510 Halsey Lane
Site
Improvements

AT&T

11/01/16 CITY SUBMITTAL

LAYOUT PLAN

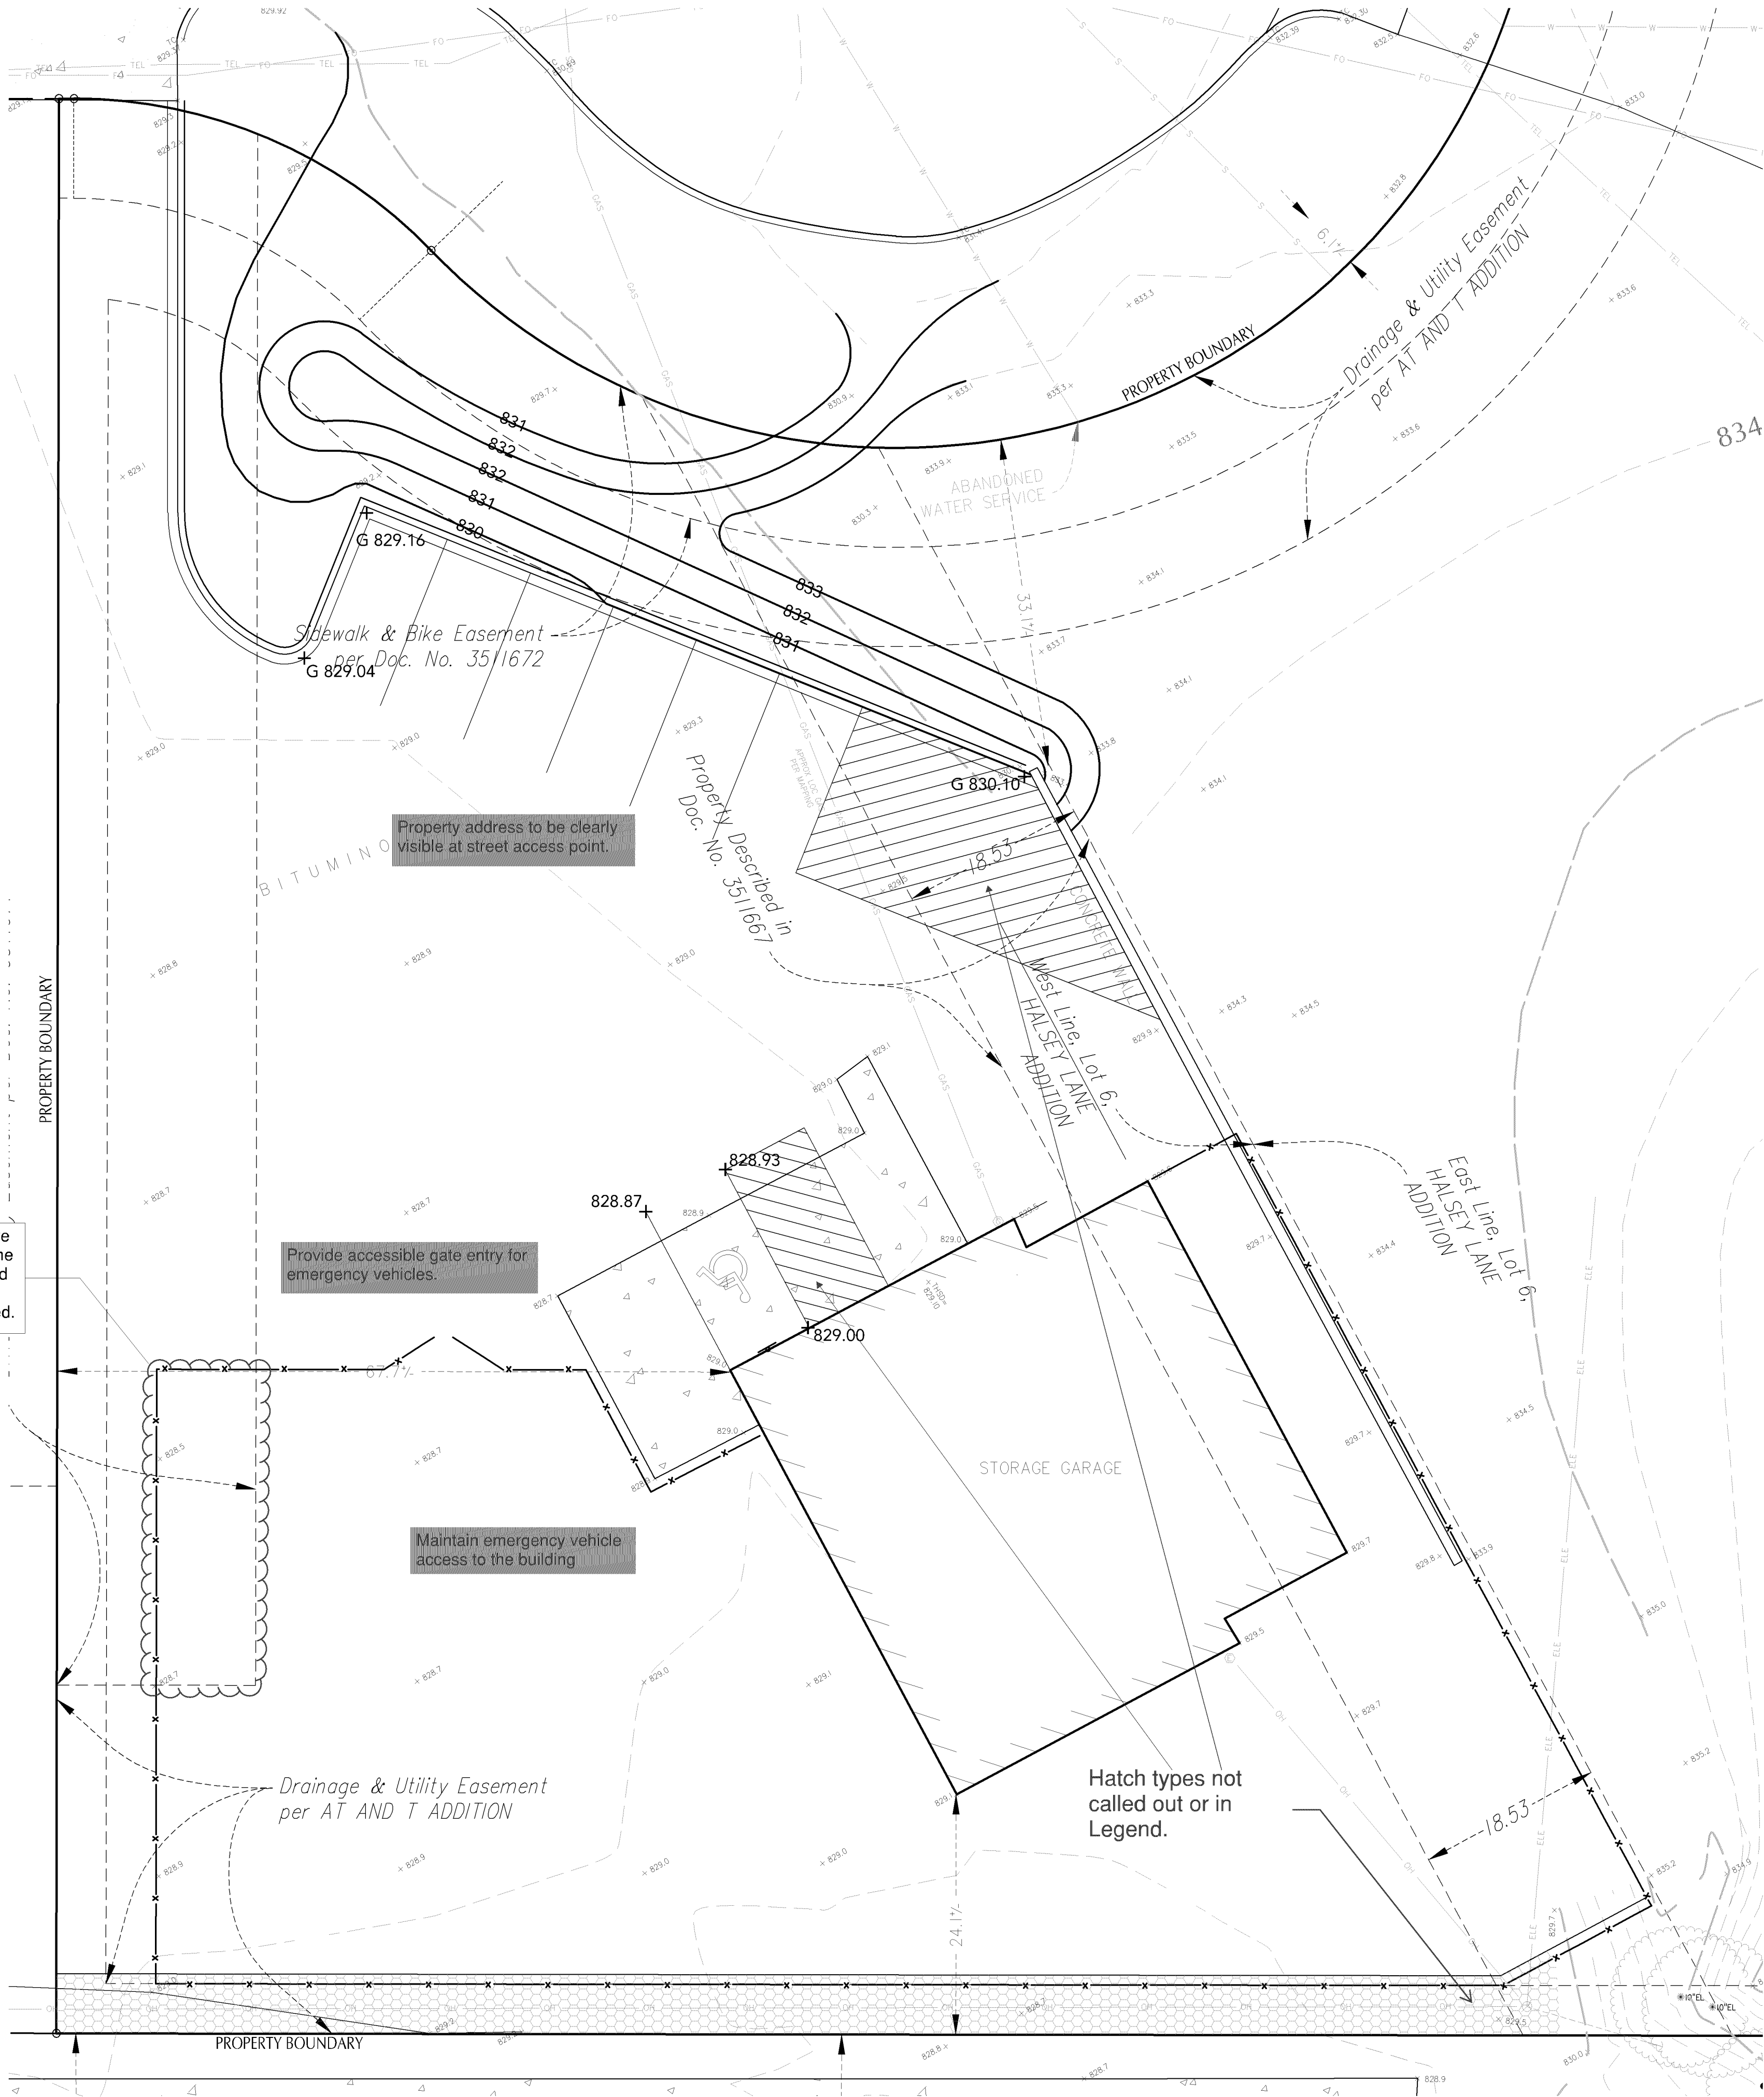
If the storage and fence are in the access easement, the property must be combined with the site to the west or easement must be modified.
